# Addendum No. 1 SUMMIT RIDGE PRS RELOCATION

PWP Bid No. WA-2015-009 October 23, 2014

## **SUMMIT RIDGE PRS RELOCATION**

D1

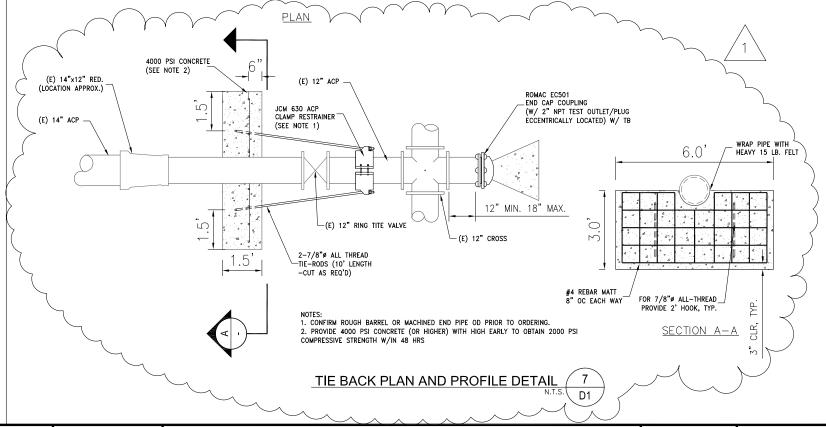
- Changes have been made to one plan sheet:
  - D1 Modified detail 7/D1, refer to sheet D1 included in this Addendum for revised plan sheet.
